ADDENDUM 1

August 3, 2023

Carthage Flats
7020 Vine Street
Cincinnati, OH 45216

Emboss Design (formerly PCA)
906 Monmouth Street
Newport, KY 41071

1. C-01 OVERALL SITE PLAN

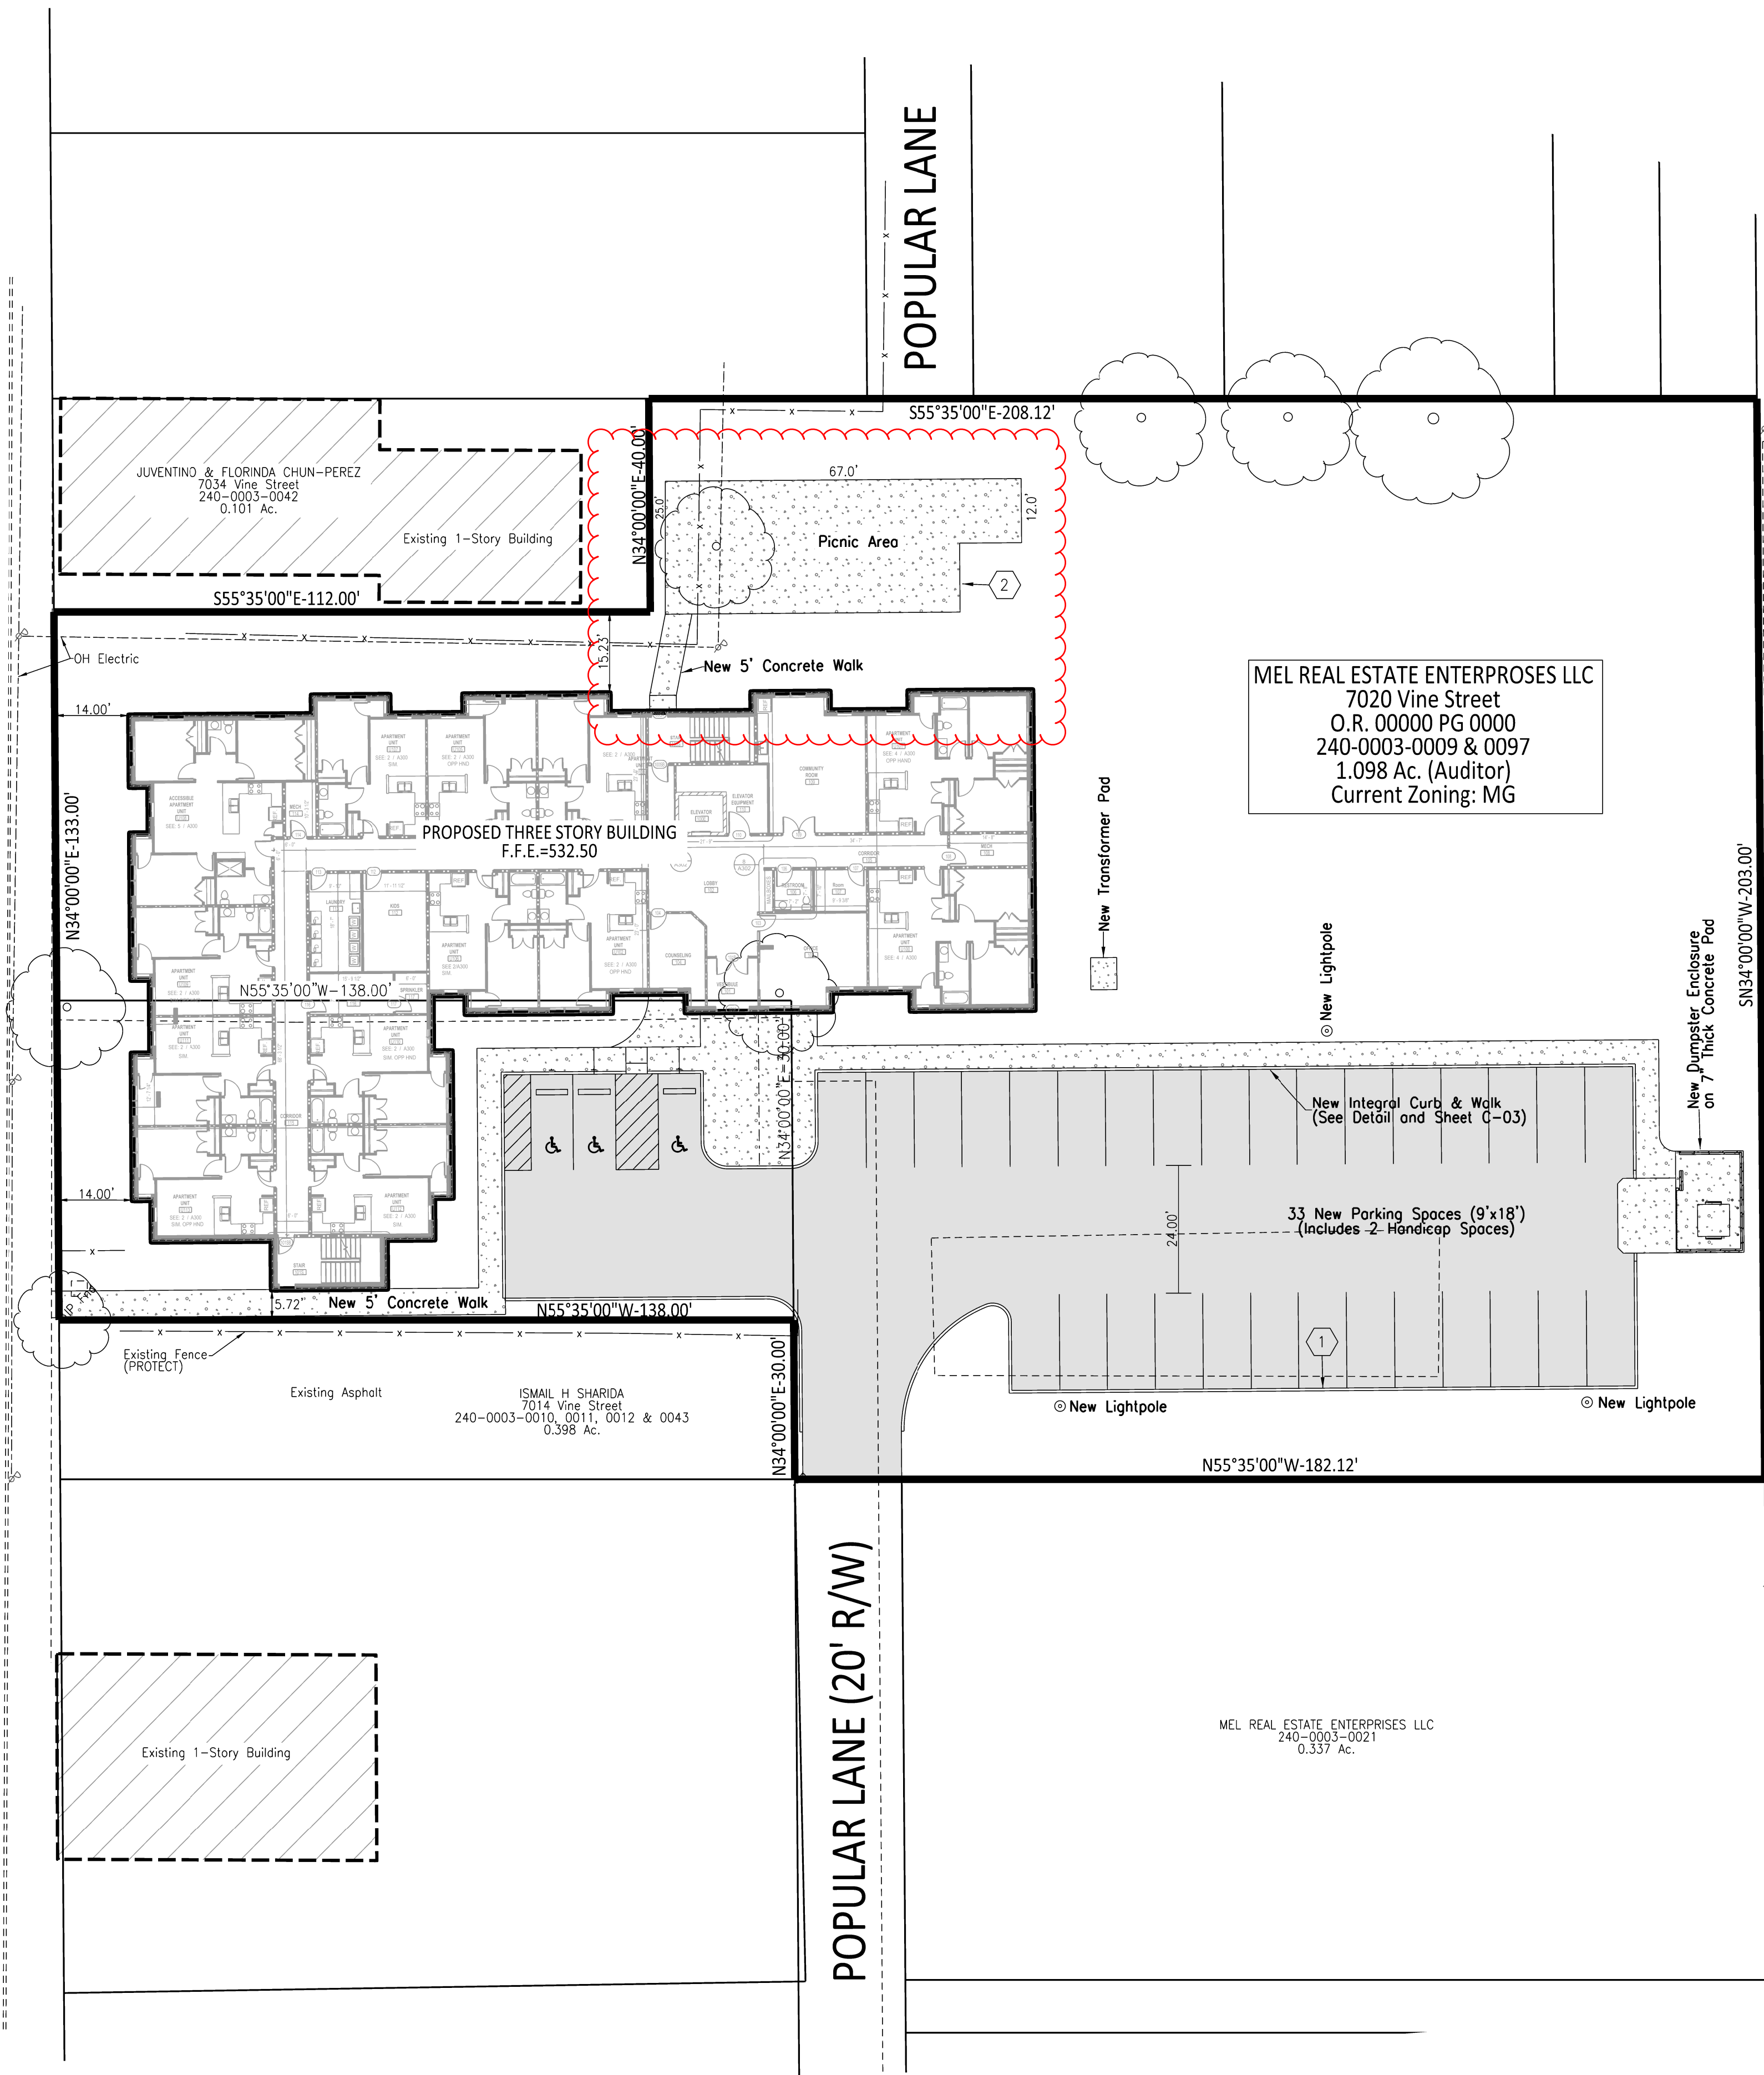
- Revised shape of Picnic Area.
- Added Note 2, description of the paving at the picnic area.

2. C-02 GRADING & UTILITY PLANS

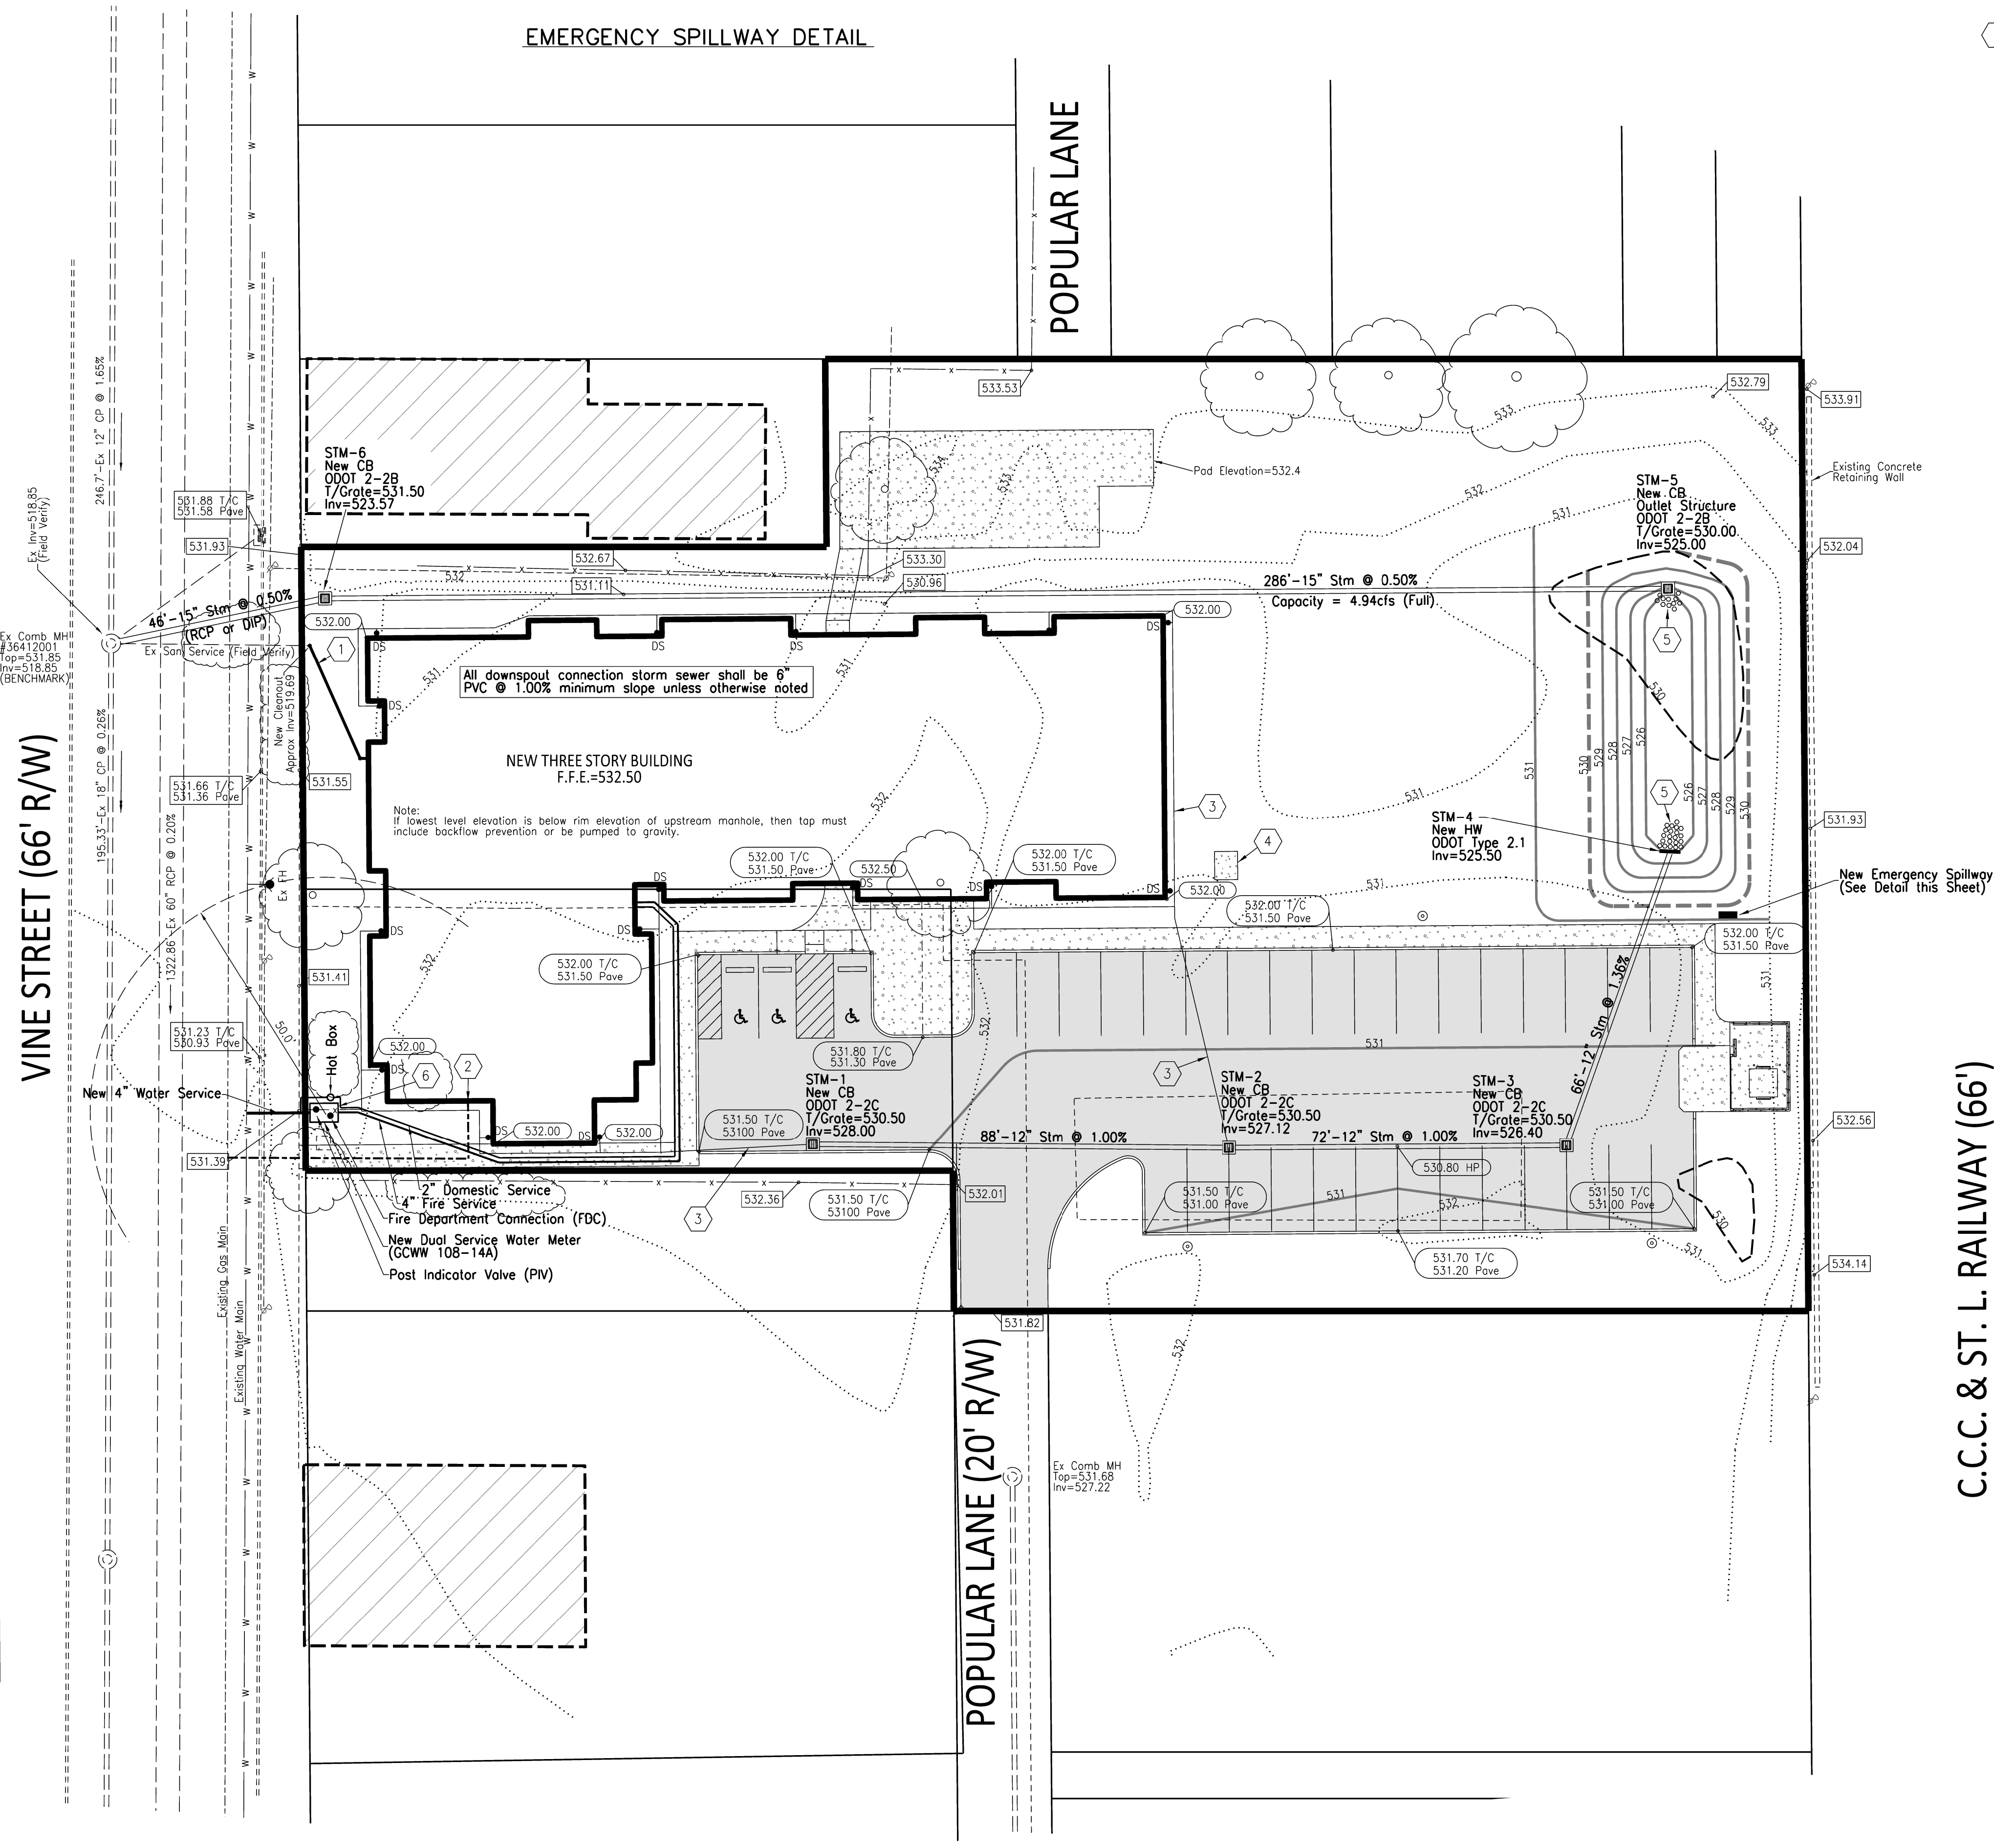
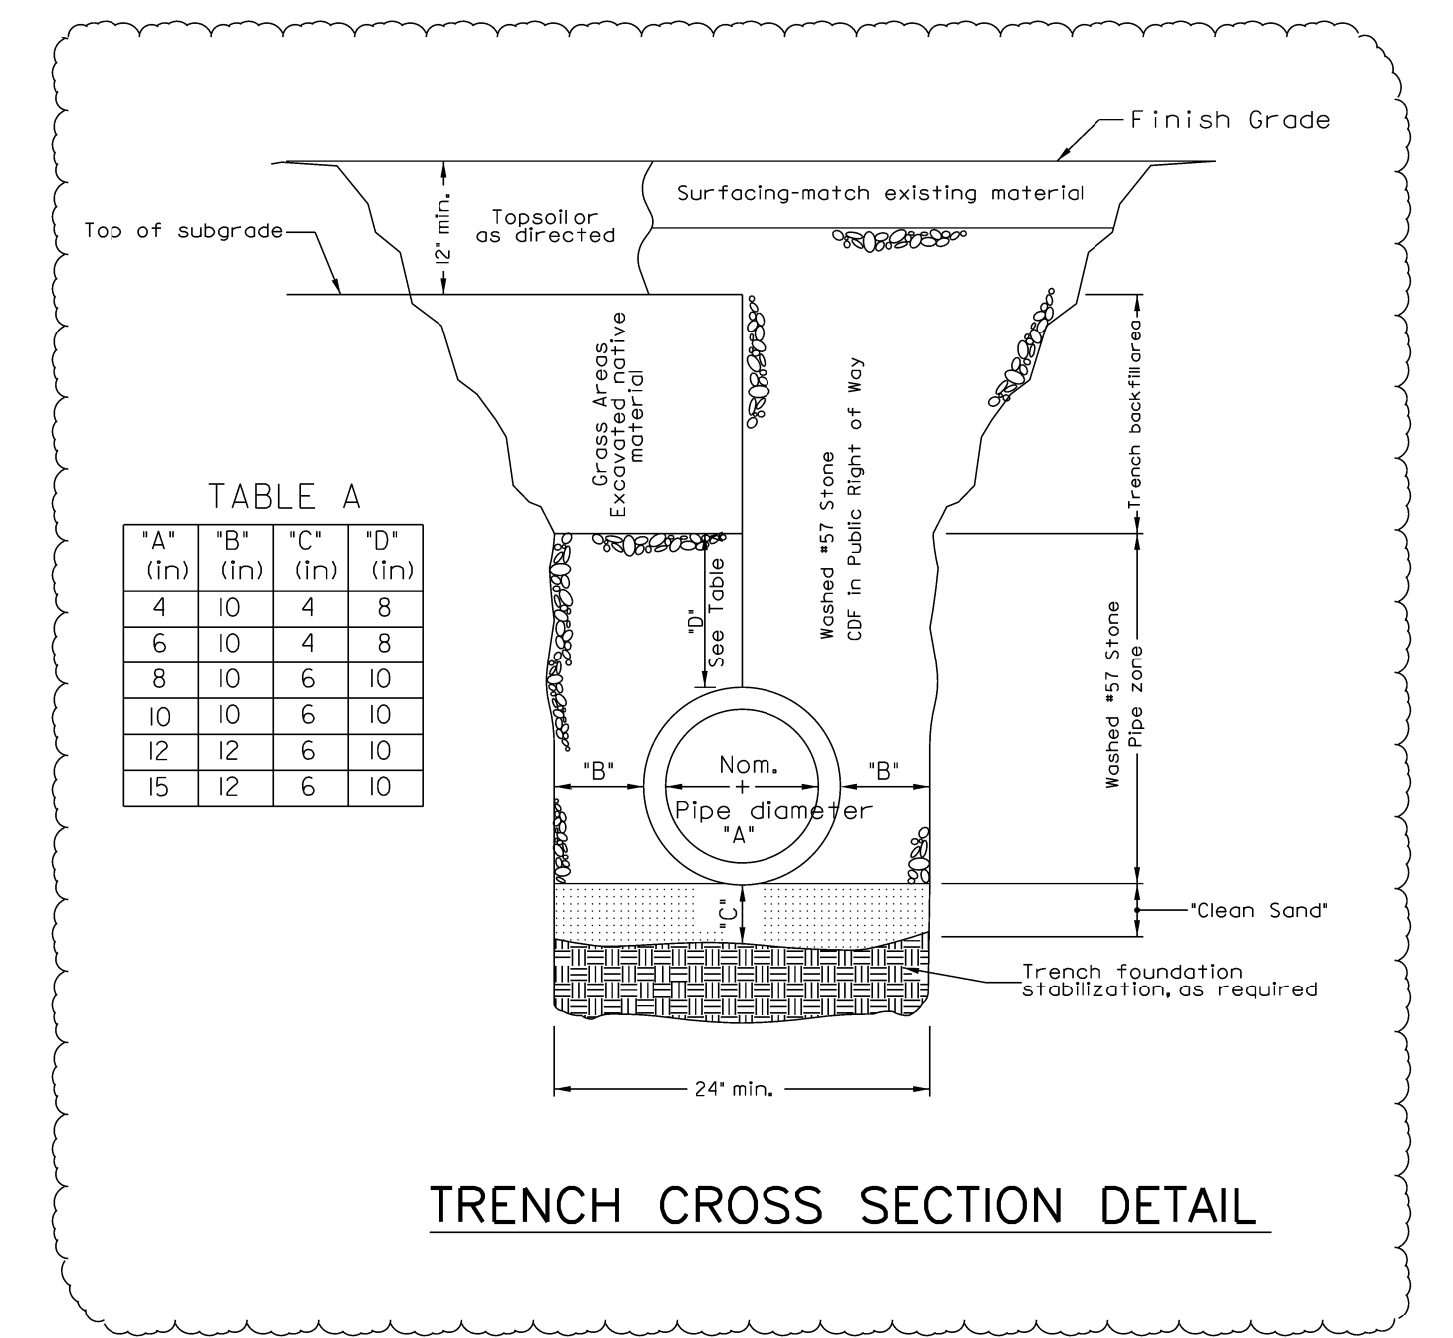
- Added top elevations and invert elevations to sheet for various pipes and structures.
- Added note for size of new water line.
- Added note for hot box.
- Revised notes for sizes and lengths of various pipes
- Added note clarifying RCP or DIP for storm sewer pipe .
- Revised water service lines entering the building.
- Added Trench cross section detail.
